Bay Farm ES

Site Committee Meeting #1

Bay Farm School Measure I Bond Project – New Classroom Bldg.

Site Committee Kick Off Meeting 3:00 pm – Zoom Meeting

BUILDING SITE LOCATIONS

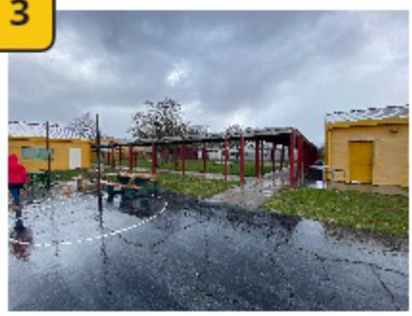
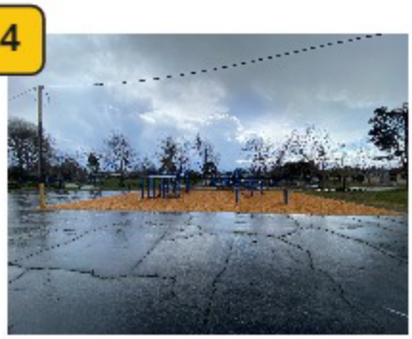
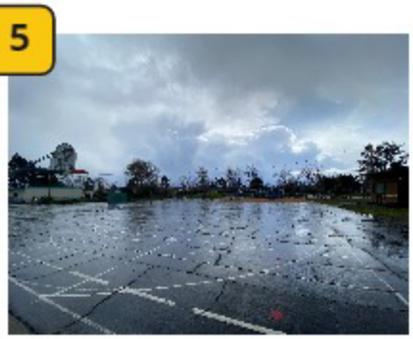
4. New Building Discussion – Location
   a. Joel presented a slide that illustrated pros and cons for two locations, location A (which was presented last meeting) and location B, at far edge of pavement near park. Thoughts and feedback:

i. Did we look at bike-rack area? And rotate it to be west facing?
      ii. Is location of option A too problematic? RC mentioned ideal place is where the portables are, but we can't put it there because we need these portables.
      iii. Soils condition? RL: likely will need piles, for either location, so both are equal in this regard.

unfortunate that we have to keep the portables in this location. would be better to place a new building here.

GENERAL BUILDING CONFIGURATIONS

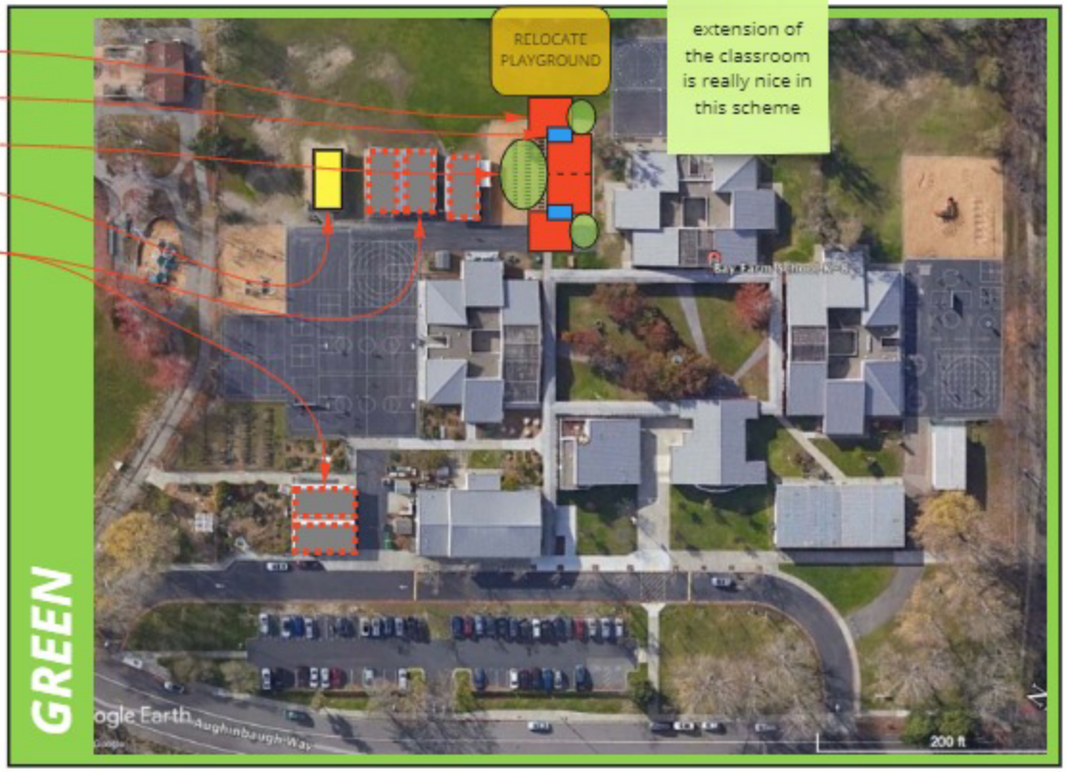
b. Joel presents three options – Green, Purple, and Blue. Feedback:
      i. General responses, big picture:
         1. All three schemes will look at both pre-engineered and site-built buildings. RL: Foundation costs will be large due to soils conditions, for either approach.

2. All three options will include similar landscaping and outdoor amenities.
      ii. Green:

1. Since new building will serve middle school, this location too close to younger kids.
2. RL: May be able to have contractor access and stage from right side of site, rather then left side.
3.

iii. Blue:
1. Since new building will serve middle school, this location too close to younger kids.
2.

iv. Purple:
1. RC likes this location better for middle school students. DM agrees.
2. Where would outdoor spaces be? KC likes green circles identified for the green and purple options.

3. AB: maybe move building up the sheet, to incorporate the yellow portable, and allow more options for outdoor learning spaces.
4. RL suggested relocating the building in this option to the 2-3 blacktop at top center of the site. Thoughts: RC does not like.

5. Joel placed L shaped building there, next to the yellow portable. Gives the middle school defined space. MK likes it for dedicated middle school gathering area. MQ: This location may be better for acoustics as well. Take a look at flooding in this area. RL: maybe make two purple options, in case flooding in this area *is* a problem. Second option would be bike rack area. Maybe with L shape. DM likes buildings "back" to be on the blacktop. Looking at garden and park. MK likes it. MQ: won't be any acoustic gain by doing this, but may be create a sense of "turning our back".

6. Next steps: discuss with Civil and do further study.

- **4,058 gsf**
- (4) 960 sf classrooms
- (2) operable walls to join classrooms into double-size rooms
- Misc. utility space
- Outdoor patios on front and rear of building
- Trellis/roof overhangs to protect outdoor patios

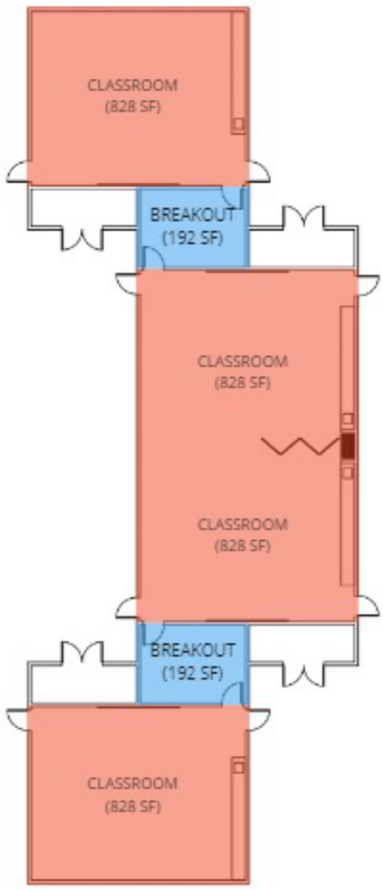
5. New Building Discussion – Program spaces – more detailed floor plans:
   a. Joel presents three schemes. Closer to 4,000 sq ft the better for budget. A building this size would not include break out spaces. Most all liked the L shaped 4,058 sf sized building best. Add doors to the back side as well, so two exits per classroom for functionality for location by garden.
   b. One option reduces size of classrooms to allow for break out spaces, which would be shared. Feedback: KC would rather have the larger room. MK agreed.
